Lakes & Waterways Advisory Board Regular Meeting August 11, 2020

Approval Shoreline Permit Applications

Shoreline Alteration Permit Staff Report (Seawall & Revetment)

Shoreline Alteration Permit Staff Report (Boathouse & Dock)

ZONVOS ELEVATION
1119 PRESERVE POINT DRIVE
WINTER PARK, FL 32789

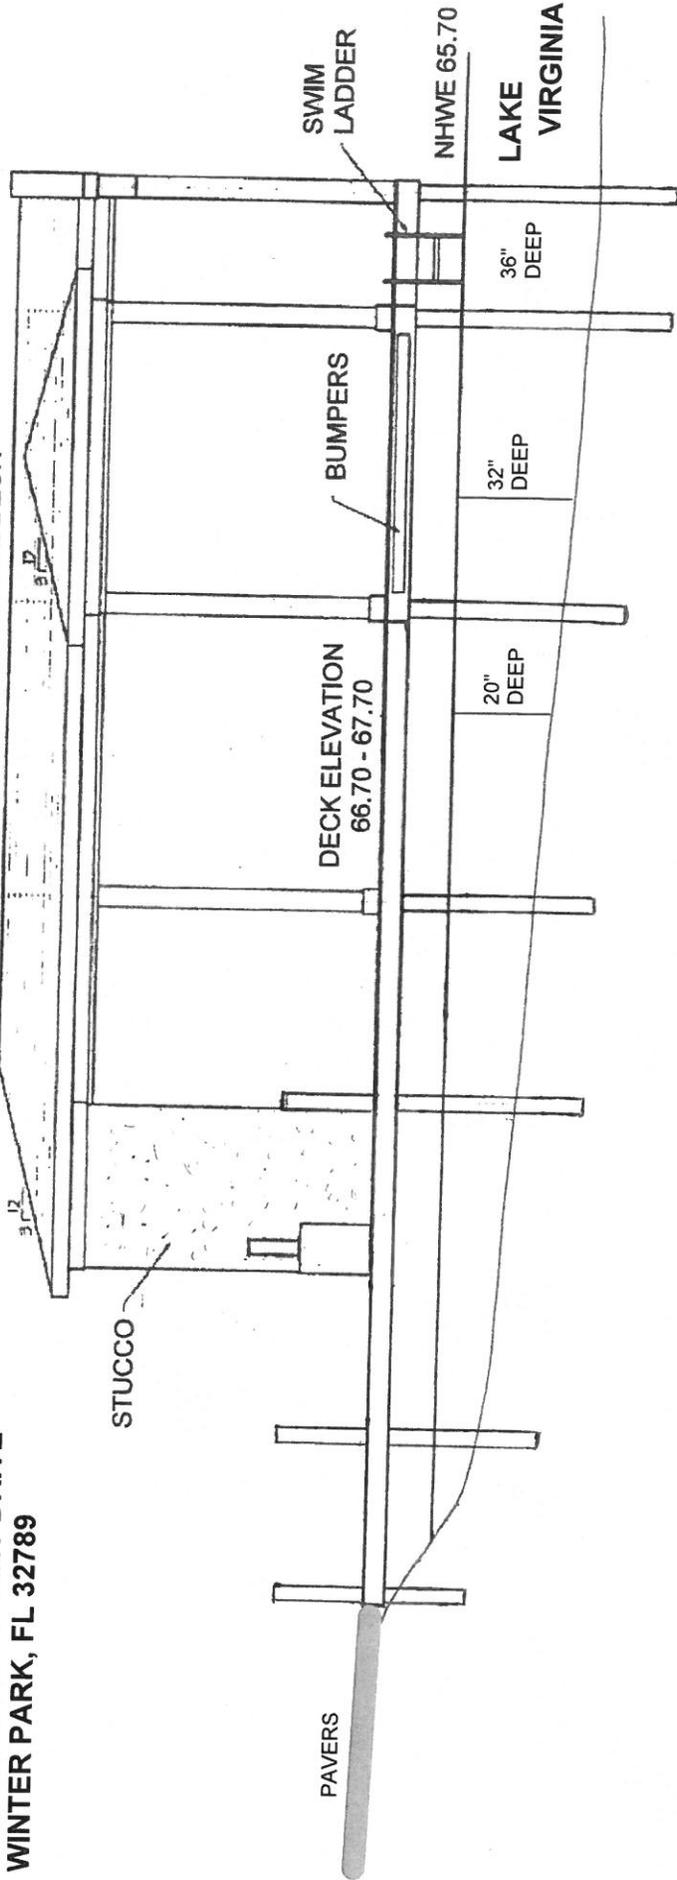
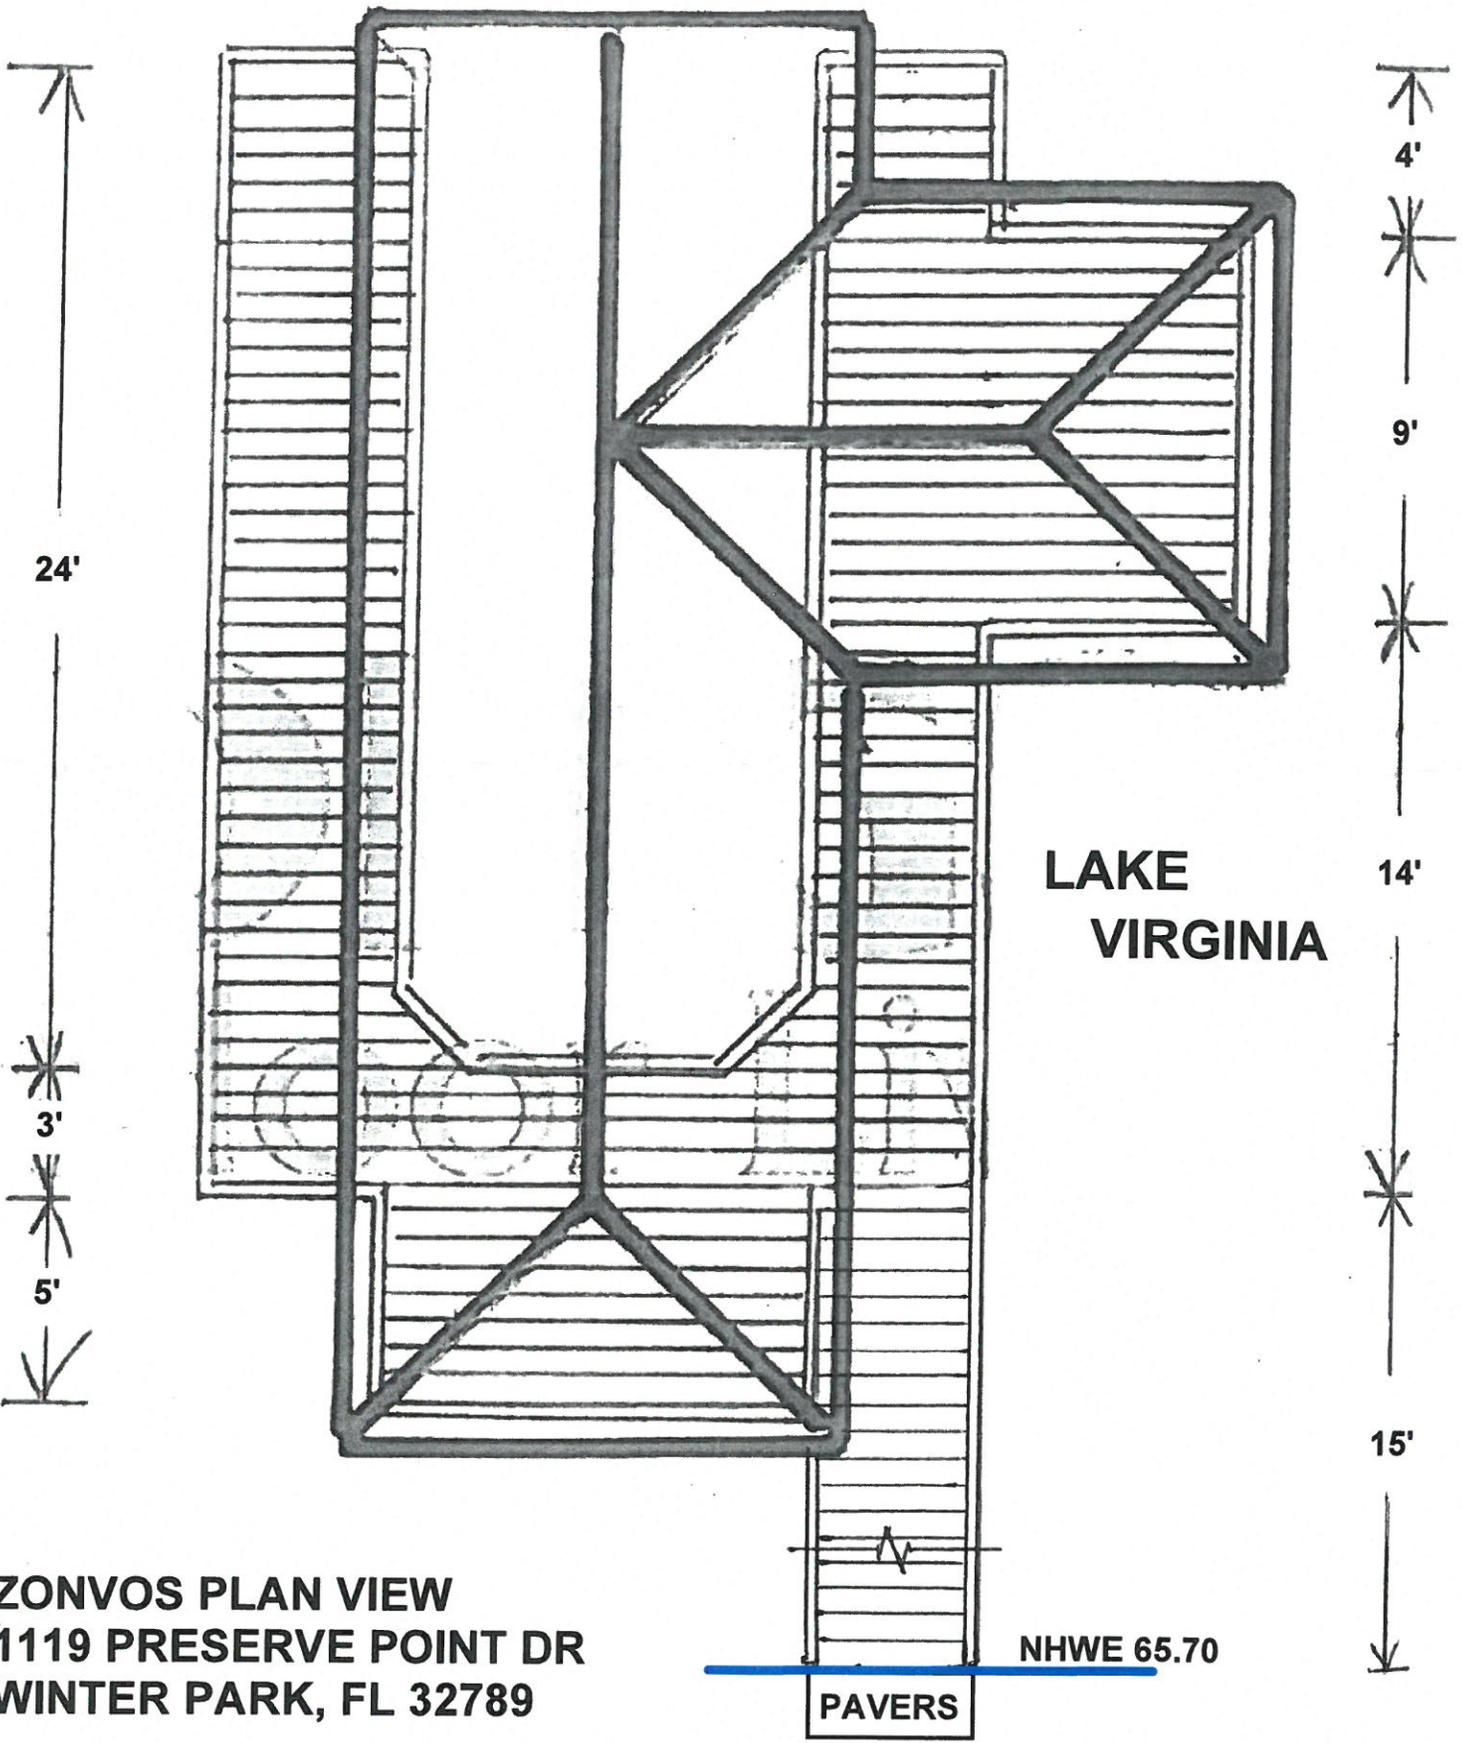
Dock Parameter	Proposed	Allowed	Variance Required?
Total Area (ft ²)	650	600 max	Yes
Length from OHW (ft)	42	30	Yes
Height of Roof (ft above deck)	11	11 max.	No
Height of Deck (ft above OHW)	1-2	2 max.	No
Enclosures?	50 SF	80 ft ² max (no plumbing/water allowed)	No
Side Yard Setback(s) (ft)	>50	10 min*	No
Meets Vegetation Criteria?	Yes	None May be Cleared.	n/a

There are cypress trees and vegetation present, but a boardwalk style dock leading to the lake should not impact the existing buffer or cypress trees/knees. The lake is shallow and additional distance from the shoreline is necessary to allow for adequate depth. Approval.

TONGSON CROSS SECTION
1703 BARCELONA WAY
WINTER PARK, FL 32789

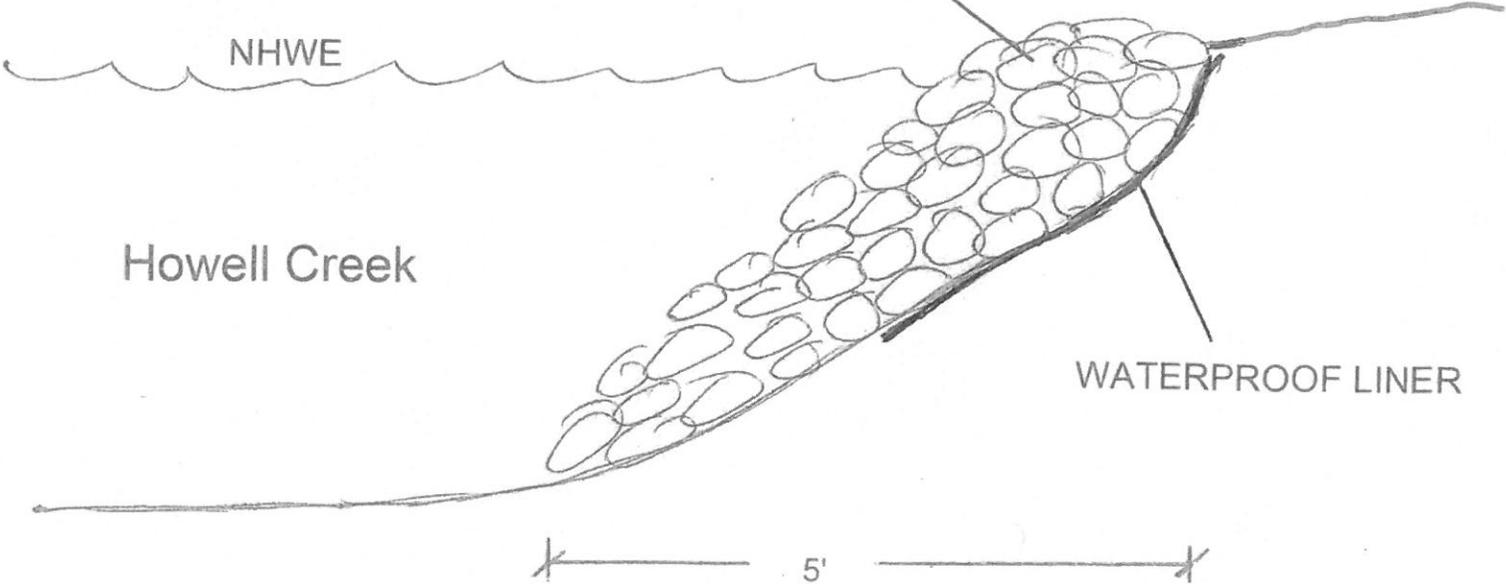
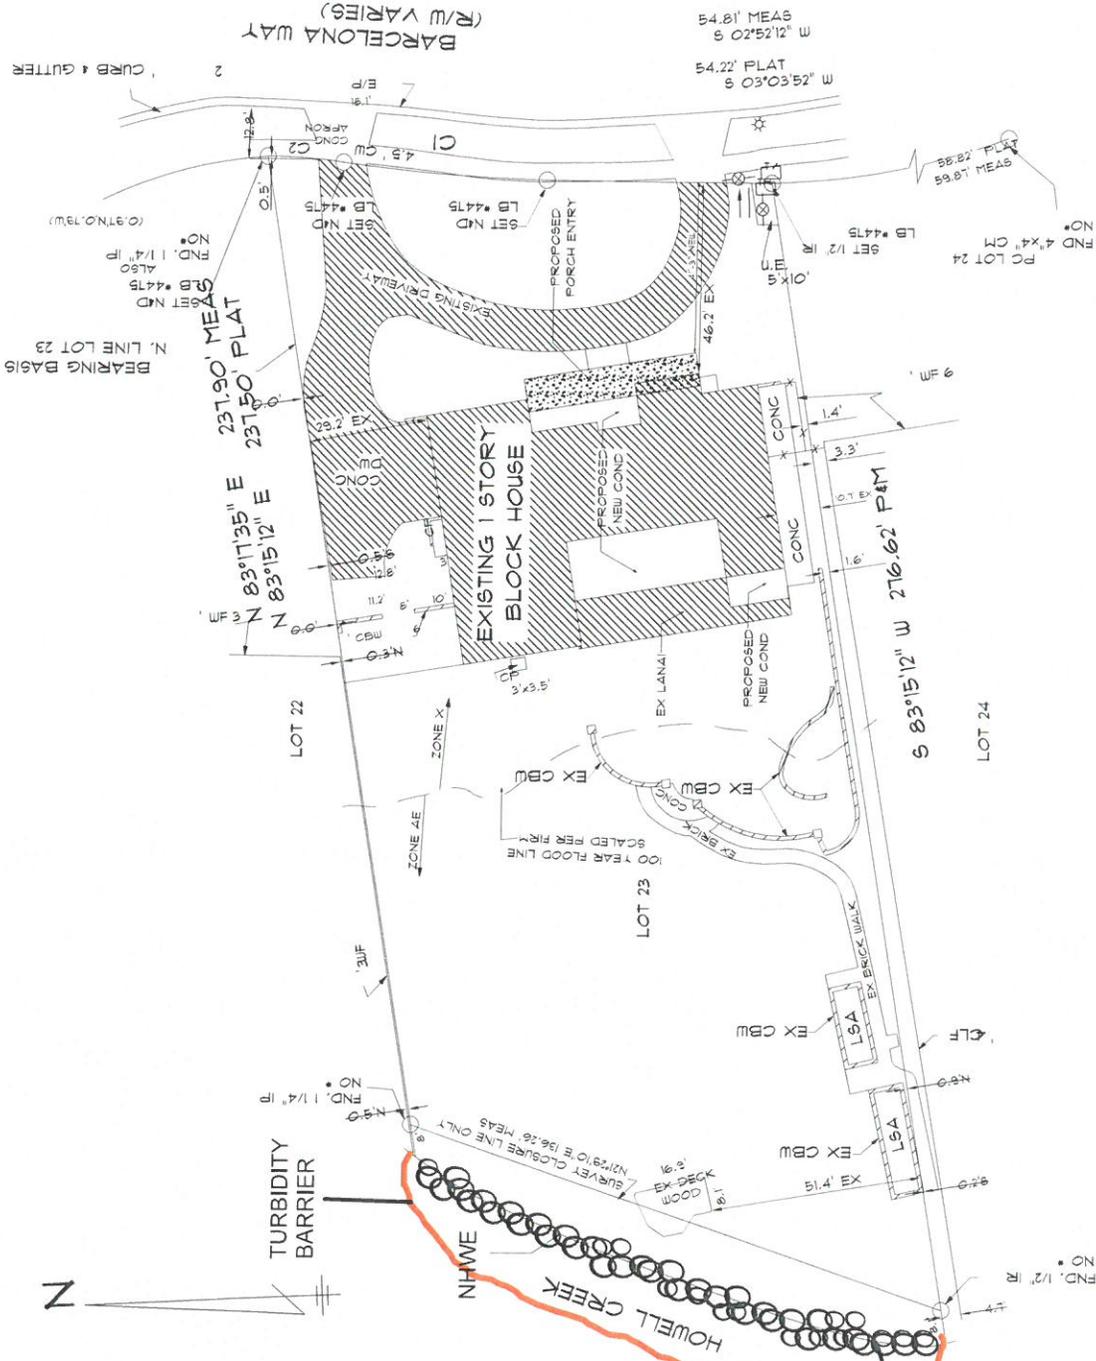
Seawall Parameter	Proposed	Allowed
Length (feet)	135'	n.a.
Slope (Horizontal:Vertical)	3:1	3:1 min.
Material	Fieldstone riprap	n.a.
Existing Erosion Problem (Yes/No)	No	Must have existing erosion problem
Meets vegetation requirement	Yes	n.a.

This project is located on Howell Creek adjacent to Mead Gardens. Applicant would like to install 135' of riprap along their shoreline at a slope of 3:1. There is currently vegetation including cypress knees along the shoreline. No erosion was identified.

Denial due to absence of erosion.
